## Inter Office Memo

SUBJECT: Advance Agenda Material – Appeal of Initial Study Application No. 7104 and Unclassified Conditional Use Permit No. 3528 (Appellant: Grand Petroleum, Inc.; Applicant: Shawn Shiralian) – October 17, 2017 Board Agenda Item (Granicus File No. 17-1168)

**August 18, 2017 Letter in Opposition**

**FIGURE 5 – SUNDAY PEAK-HOUR PROJECT TRAFFIC VOLUMES**

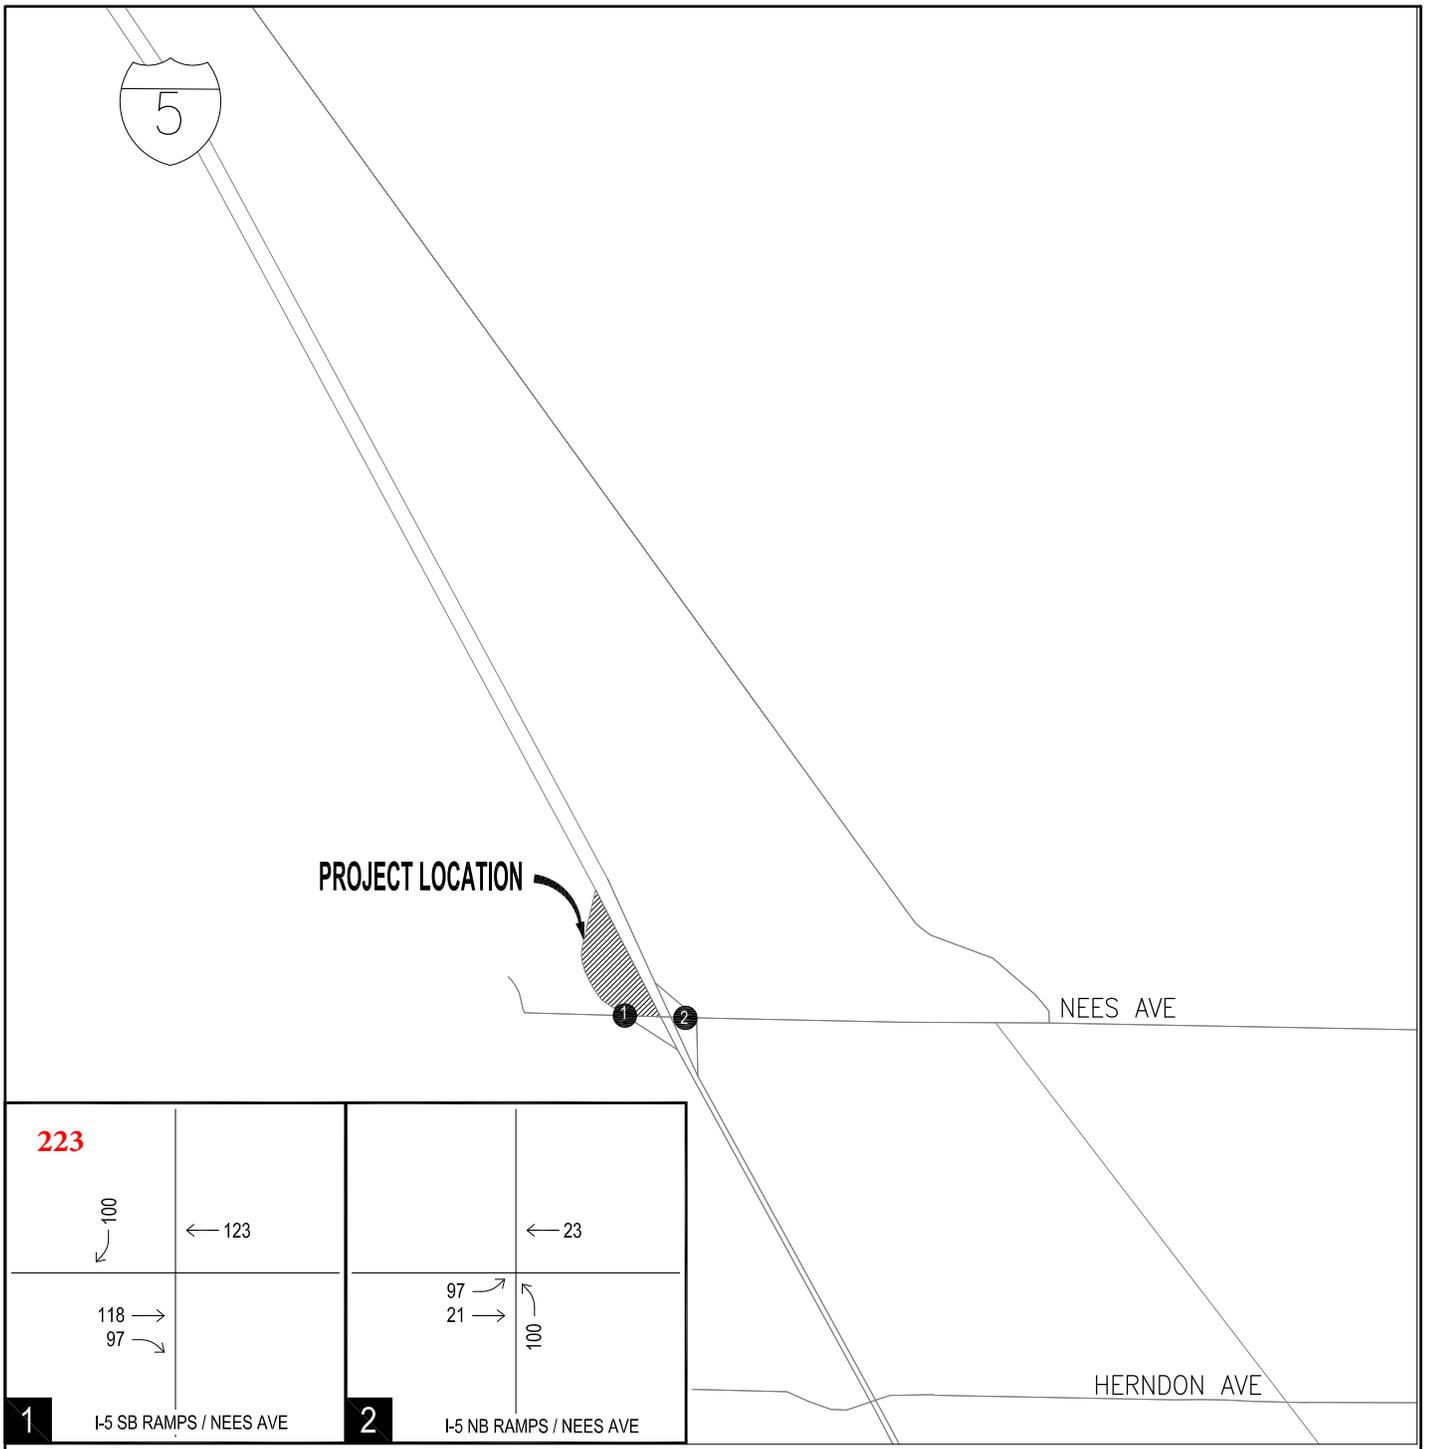
4. **Project Traffic Assignment is Flawed** – Figure 5 in the PEG study illustrates the assignment of Project-generated trips to the study intersections. For ease of reference, that figure is presented here as Attachment C, with the total peak-hour volume of Project-generated traffic west of the Nees Avenue/I-5 Southbound Ramps intersection noted in red. As shown there, Figure 5 shows 223 westbound project trips traveling toward the Project site and 215 eastbound trips departing the Project site.

However, PEG Table 6 (p. 8), which summarizes the Project trip generation estimate employed in the analysis, shows that the Project is estimated to generate 228 inbound trips and 222 outbound trips. Consequently, the Project traffic assignment values shown in Figure 5 represent a shortage of 5 inbound trips and 7 outbound trips. This is summarized in Table 1 below.

**FIGURE 5 – SUNDAY PEAK-HOUR PROJECT TRAFFIC VOLUMES**

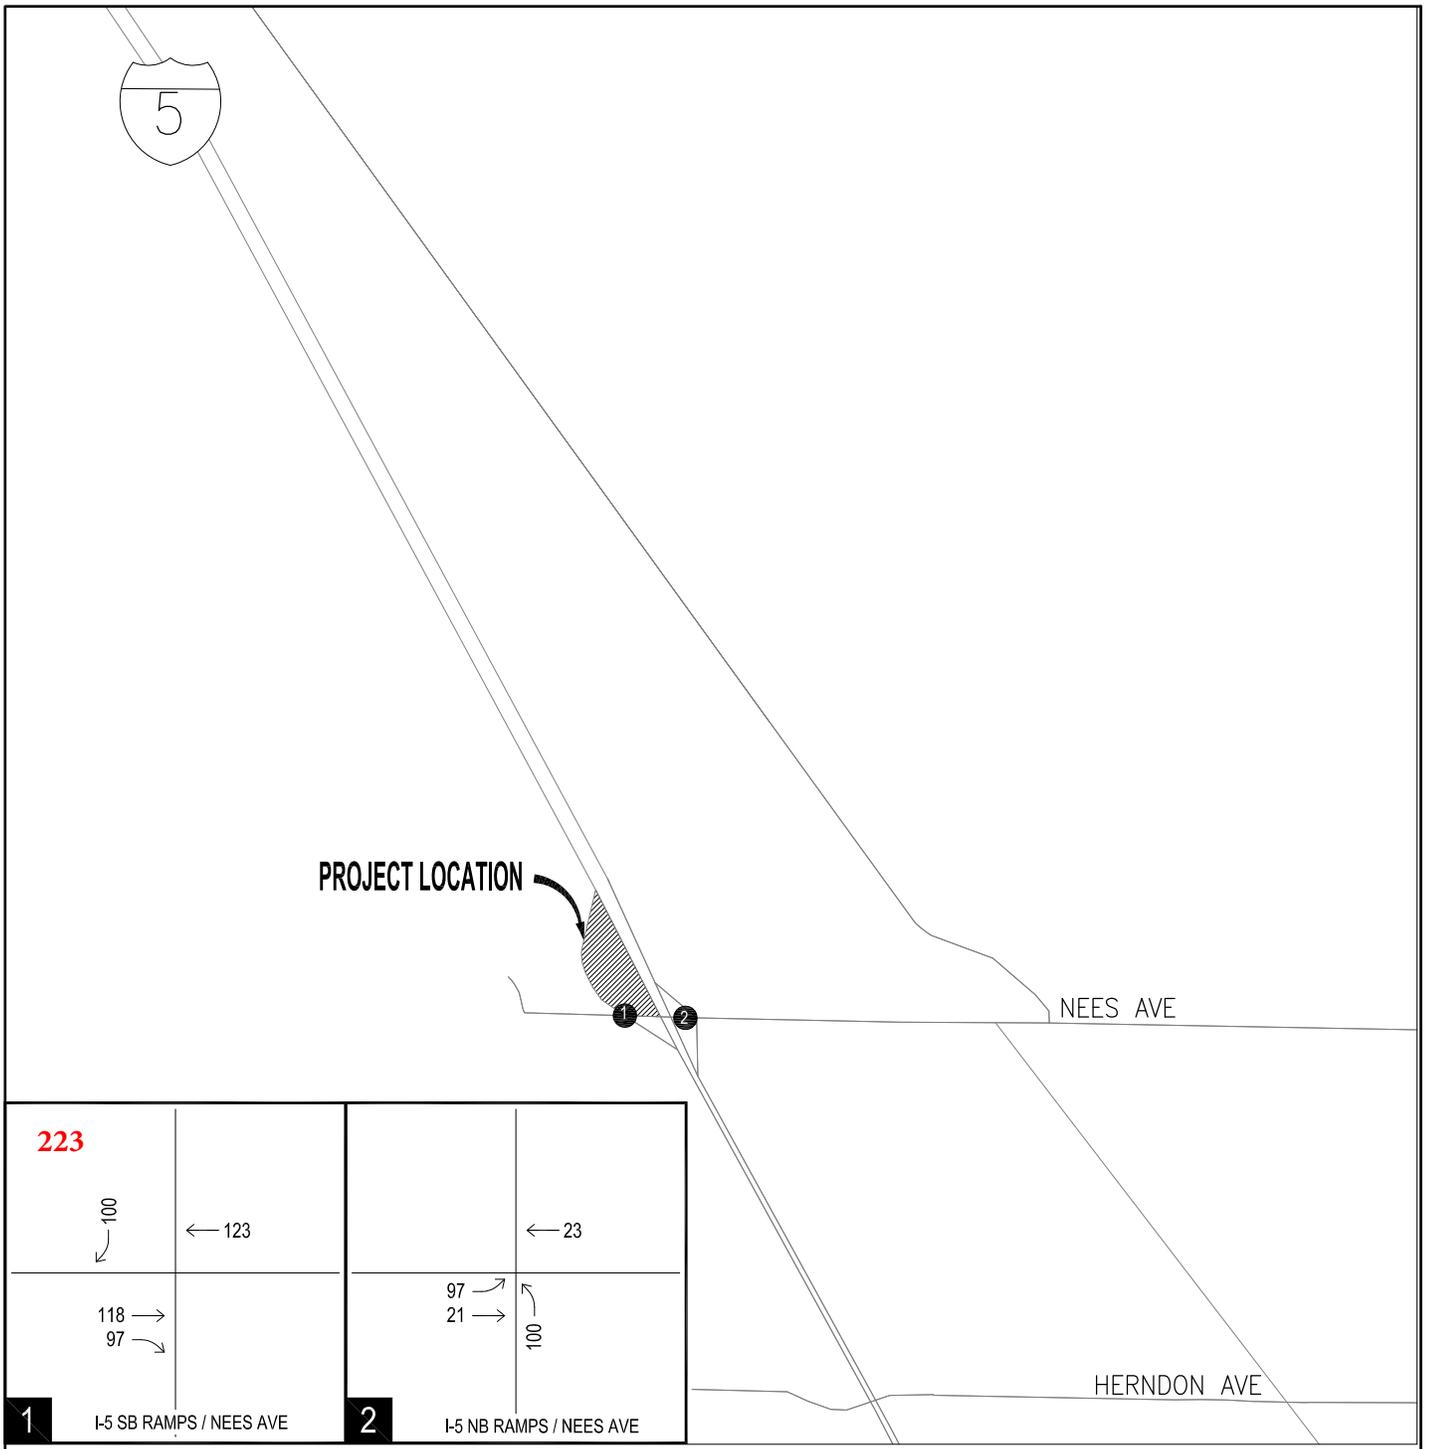
4. **Project Traffic Assignment is Flawed** – Figure 5 in the PEG study illustrates the assignment of Project-generated trips to the study intersections. For ease of reference, that figure is presented here as Attachment C, with the total peak-hour volume of Project-generated traffic west of the Nees Avenue/I-5 Southbound Ramps intersection noted in red. As shown there, Figure 5 shows 223 westbound project trips traveling toward the Project site and 215 eastbound trips departing the Project site.

However, PEG Table 6 (p. 8), which summarizes the Project trip generation estimate employed in the analysis, shows that the Project is estimated to generate 228 inbound trips and 222 outbound trips. Consequently, the Project traffic assignment values shown in Figure 5 represent a shortage of 5 inbound trips and 7 outbound trips. This is summarized in Table 1 below.

# High-Turnover (Sit-Down) Restaurant (932)

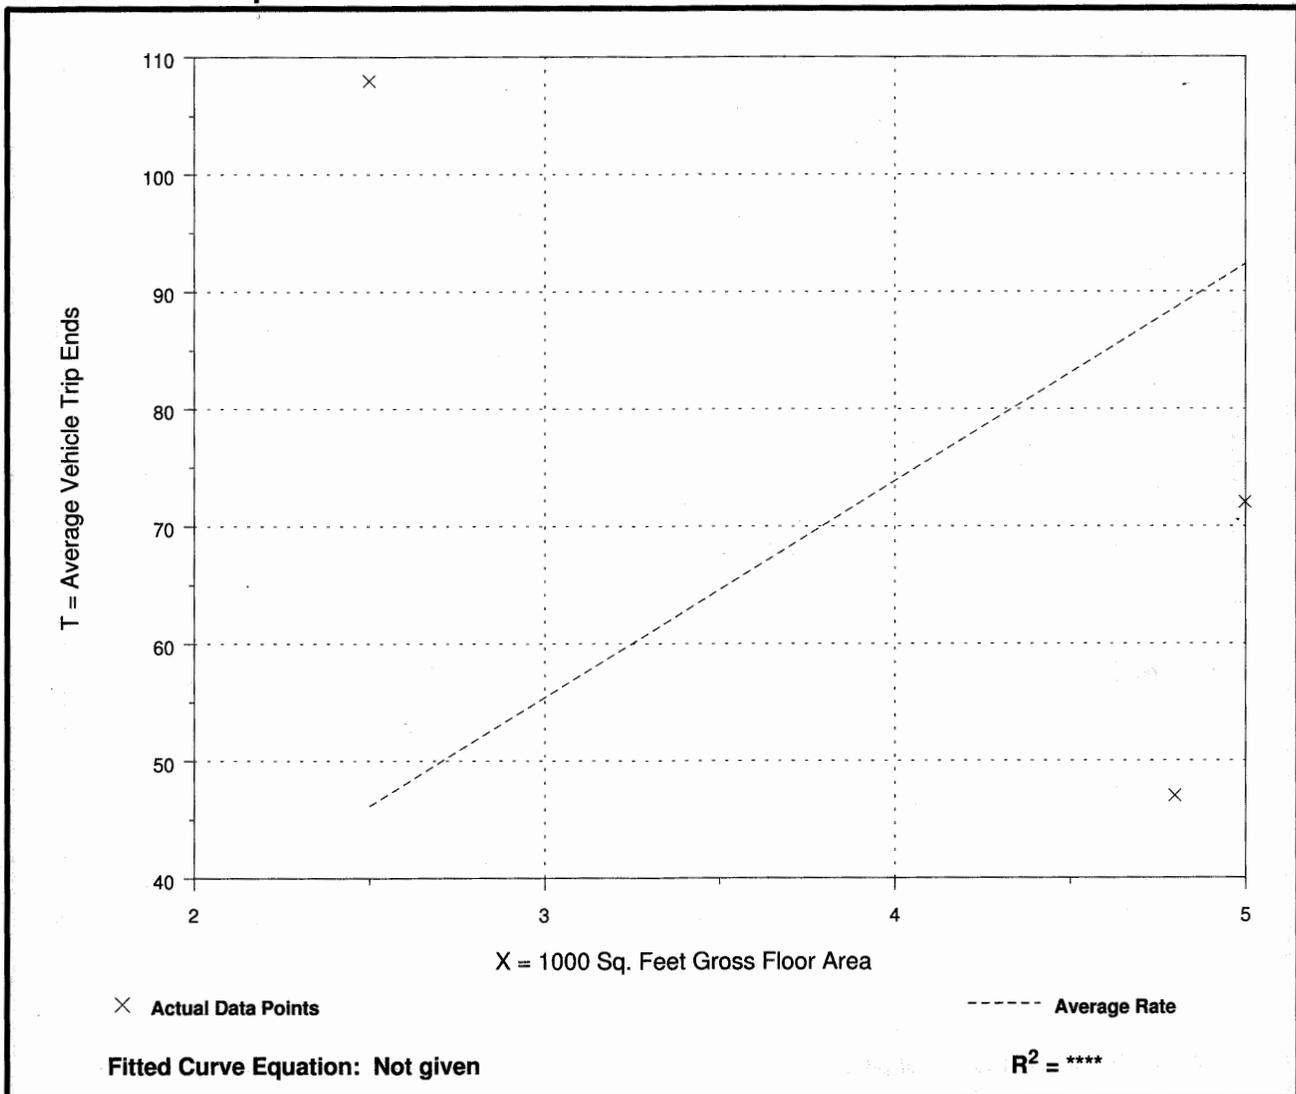
We also question the approach taken with regard to estimating the number of trips generated by the proposed 4,800 SF sit-down restaurant. For trip generation purposes, the size of the proposed restaurant has been arbitrarily reduced by 1,000 SF to reflect an apparent guess concerning the size of the existing Subway sandwich shop within the Chevron station where trip data was collected. In other words, the traffic analysis addresses a 3,800 SF restaurant, instead of the actual 4,800 SF facility. While the intent is to account for the fact that the Subway trips are included within the total number of trips counted at the Chevron driveway, the validity of the specific adjustment is not adequately demonstrated.

**FIGURE 5 – SUNDAY PEAK-HOUR PROJECT TRAFFIC VOLUMES**

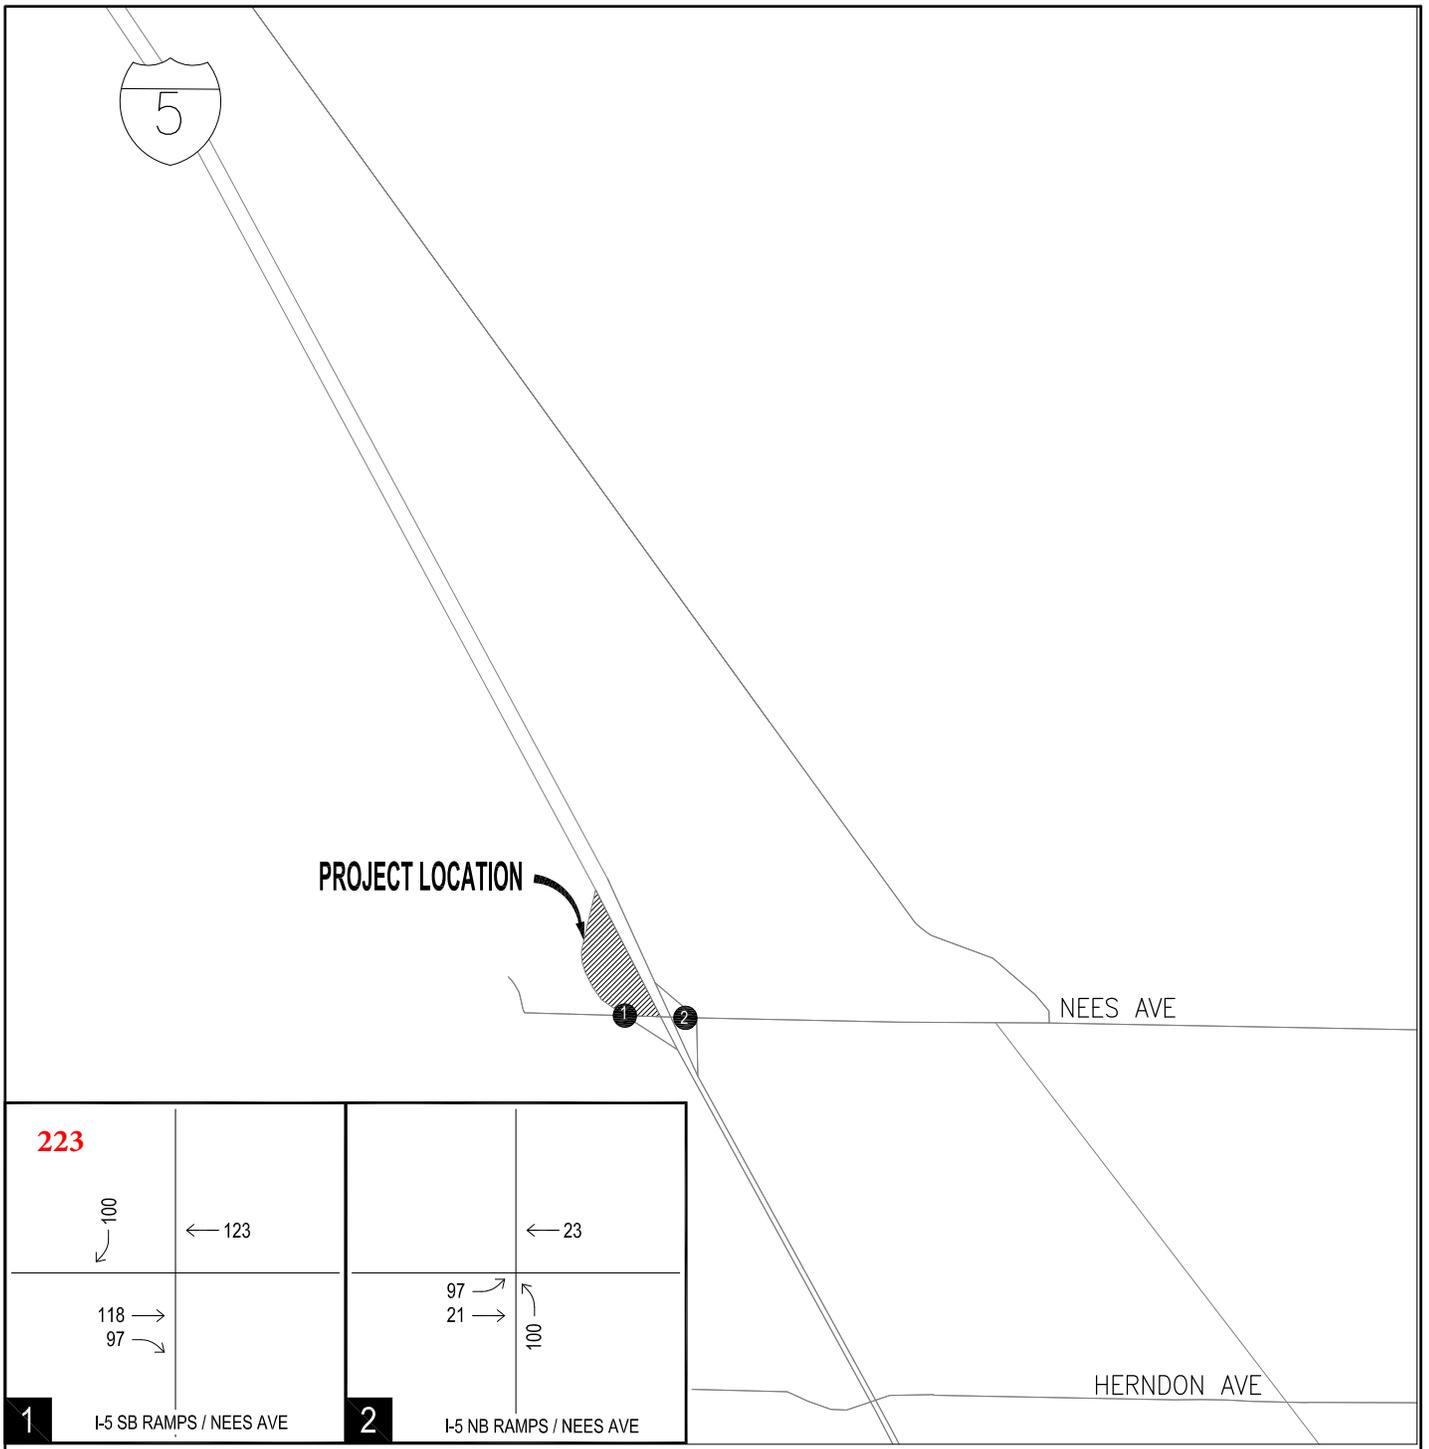
4. **Project Traffic Assignment is Flawed** – Figure 5 in the PEG study illustrates the assignment of Project-generated trips to the study intersections. For ease of reference, that figure is presented here as Attachment C, with the total peak-hour volume of Project-generated traffic west of the Nees Avenue/I-5 Southbound Ramps intersection noted in red. As shown there, Figure 5 shows 223 westbound project trips traveling toward the Project site and 215 eastbound trips departing the Project site.

However, PEG Table 6 (p. 8), which summarizes the Project trip generation estimate employed in the analysis, shows that the Project is estimated to generate 228 inbound trips and 222 outbound trips. Consequently, the Project traffic assignment values shown in Figure 5 represent a shortage of 5 inbound trips and 7 outbound trips. This is summarized in Table 1 below.
